FINAL REPORT

ARIZONA CANAL DIVERSION CHANNEL AESTHETICS COMMITTEE

MAY 5, 1989

RE: Transmittal of ACDC Aesthetics Committee Final Report
for Review and Comment

Figure 22. REACH 4: STANFORD DRIVE TO CUDIA
 CITY WASH/39TH STREET, EASTERN
 TERMINUS OF ACDC (SUBREACH 1)

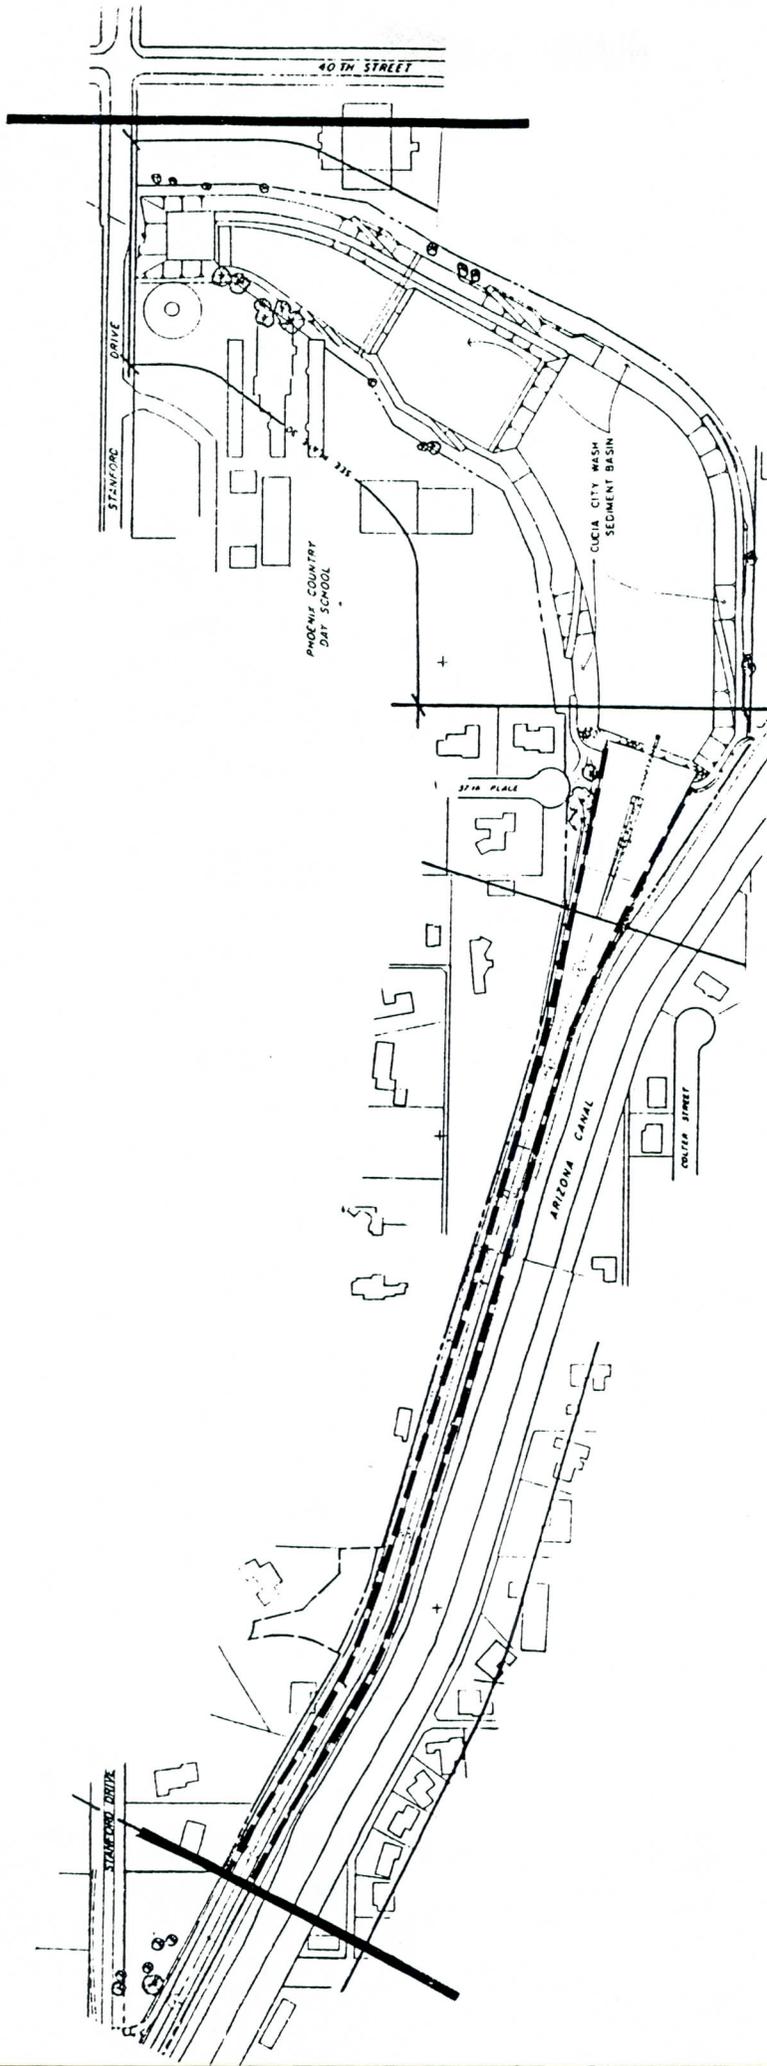
This subreach received a "moderate" priority for covering/decking. It consists mostly of a broad sediment basin; and decking is not feasible.
